IFB No. 21-12 Administration Building First Floor Renovations

RE: **ADDENDUM NO. 1**

Changes to Bidding Documents Dated May 23, 2019

PROJECT: RPS 205 ADMINISTRATION BUILDING  
FIRST FLOOR RENOVATION  
ROCKFORD, ILLINOIS

DATE: 02-22-2021	ISSUED FOR: DATE: 03/12/2021	PROJECT NUMBER: 31010	SHEET NUMBER: D1.1	DRAWN: [blank]	APPROVED: [blank]
------------------	------------------------------	-----------------------	--------------------	----------------	-------------------

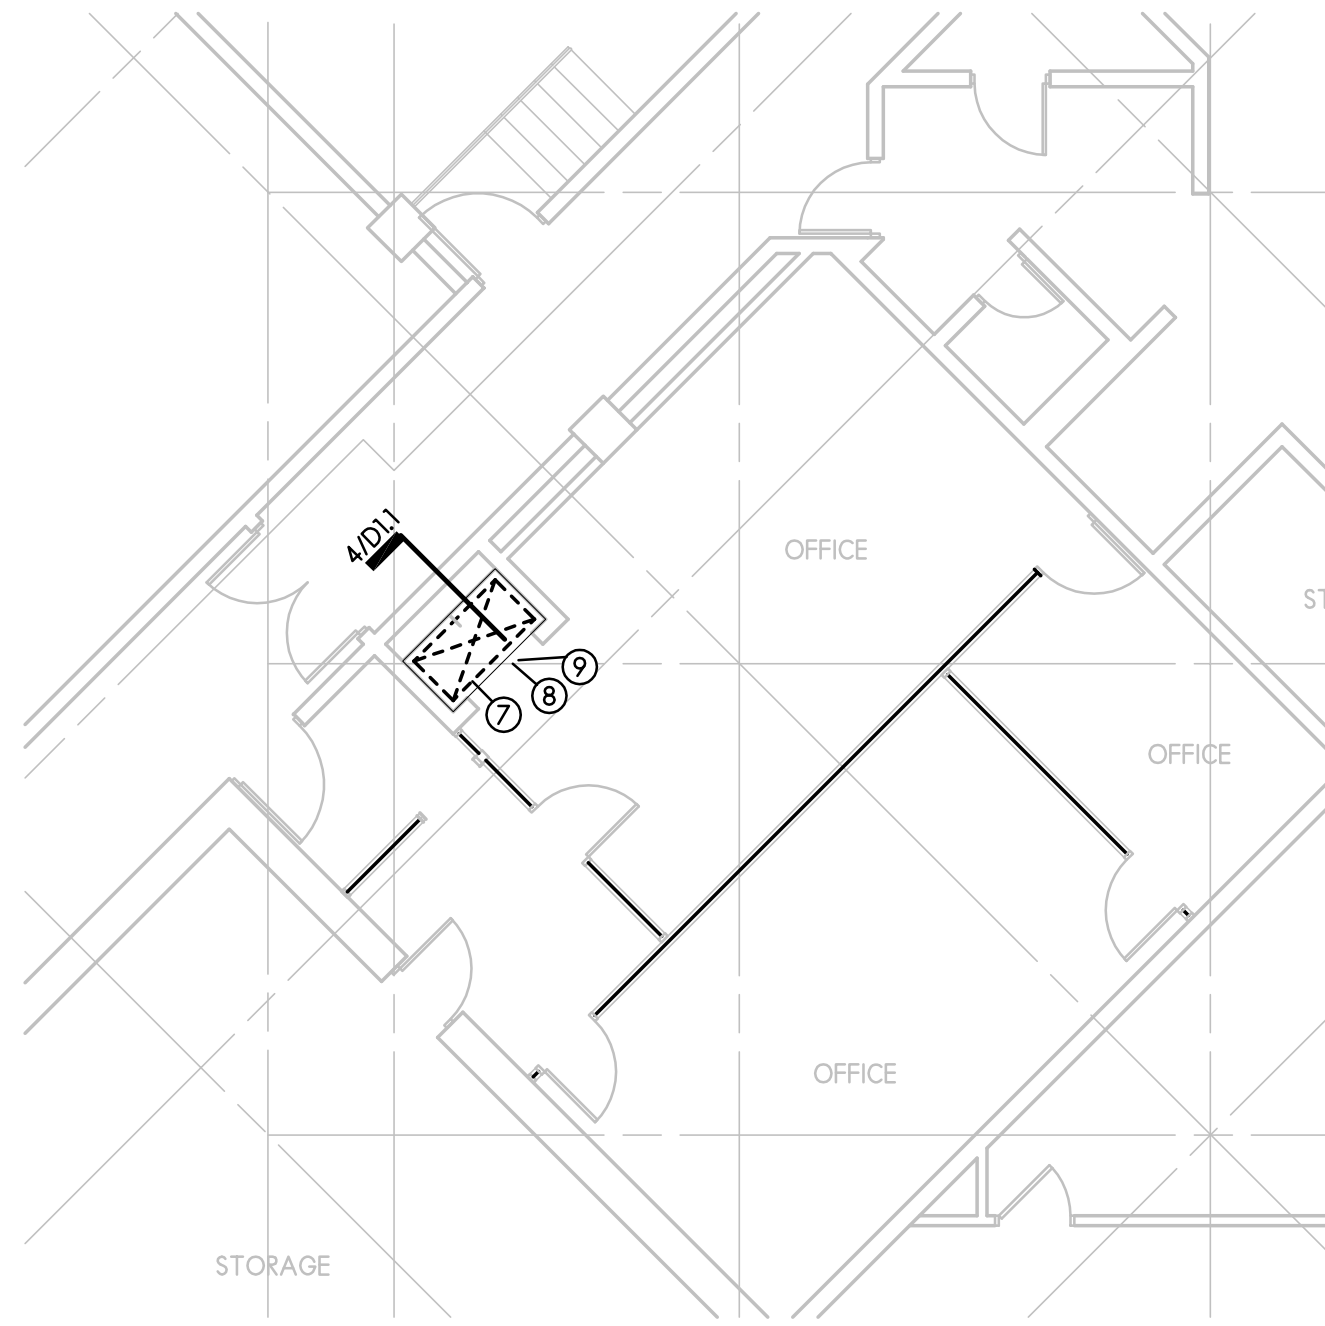
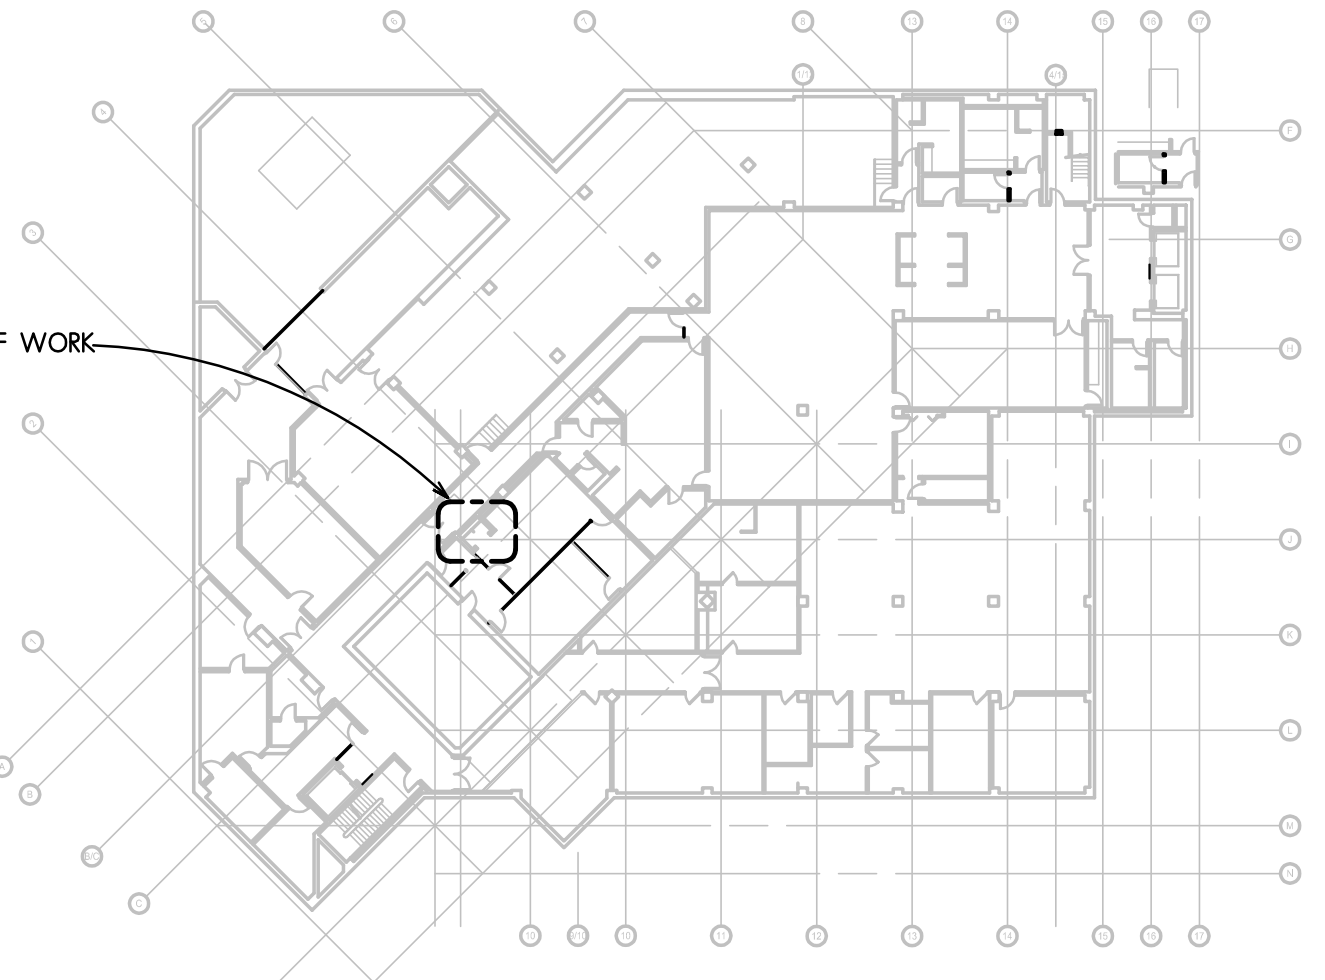
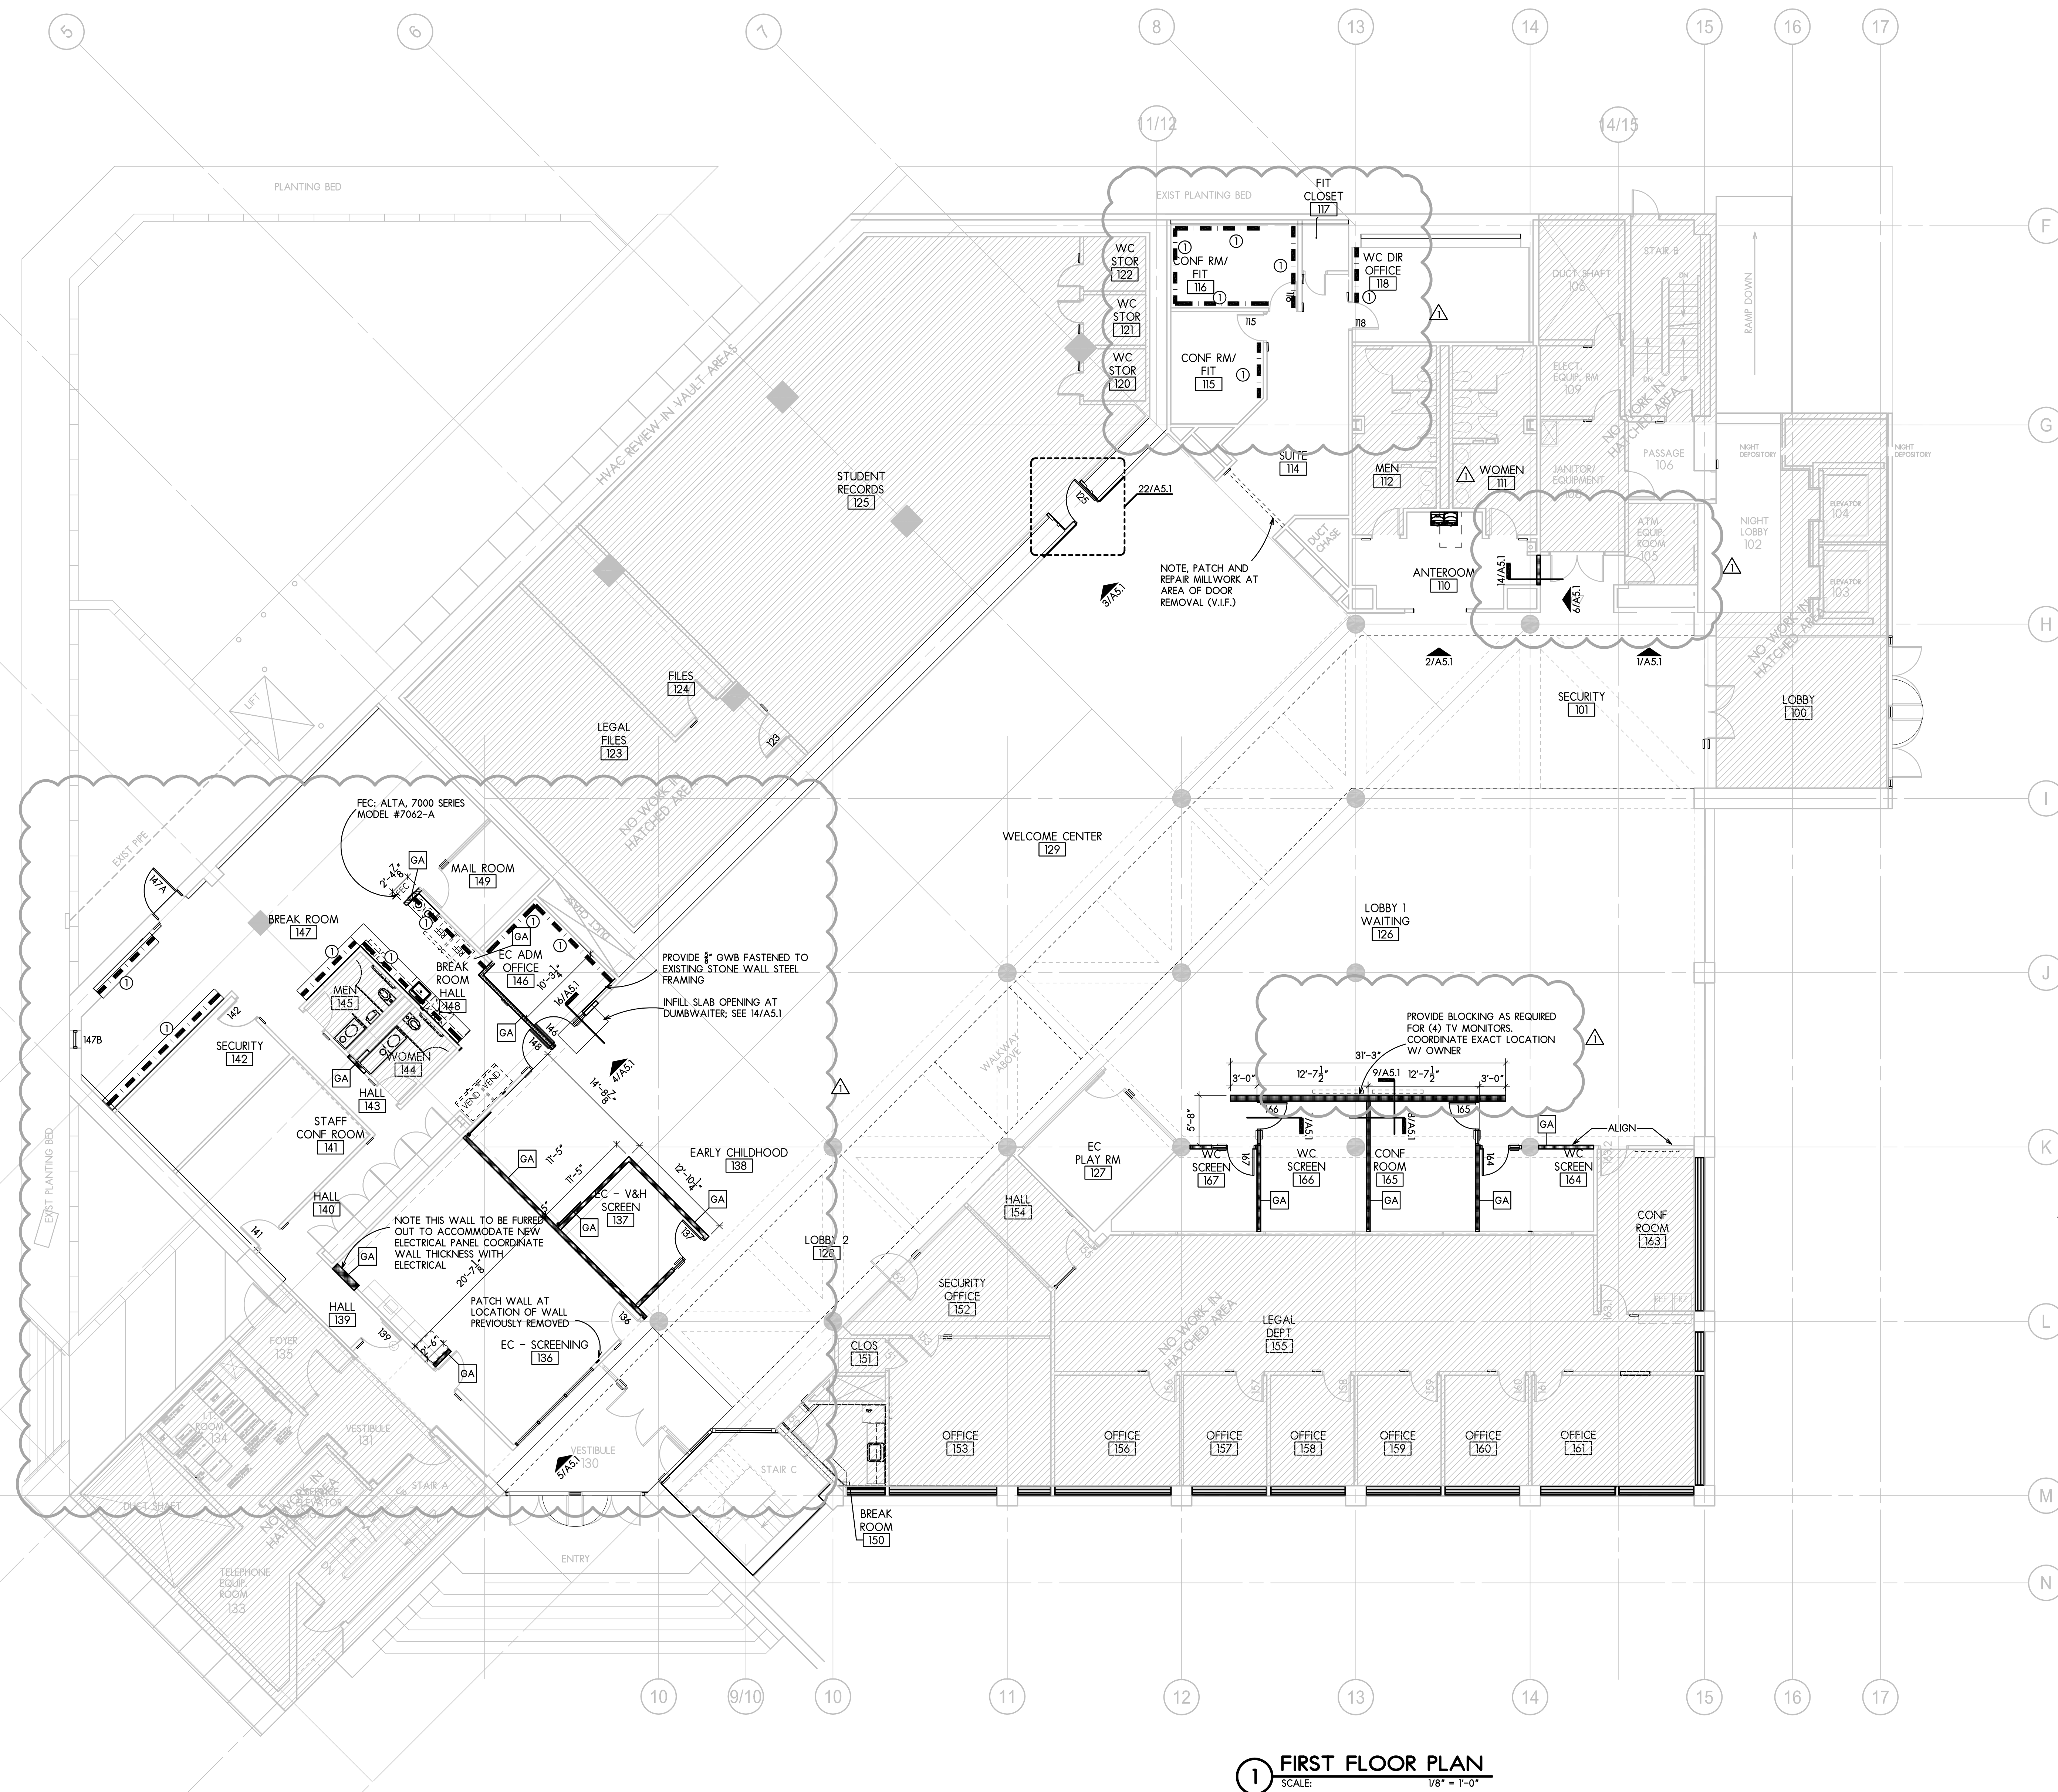
- 17- REMOVE EXISTING GWB CEILING AT 3RD FLOOR BRIDGE.
  - 18- REMOVE UPPER PORTION OF EXISTING WALL AS REQUIRED TO INSTALL ALUM & GLASS CLEAR STORY. SEE SECTION 101A/5.1.
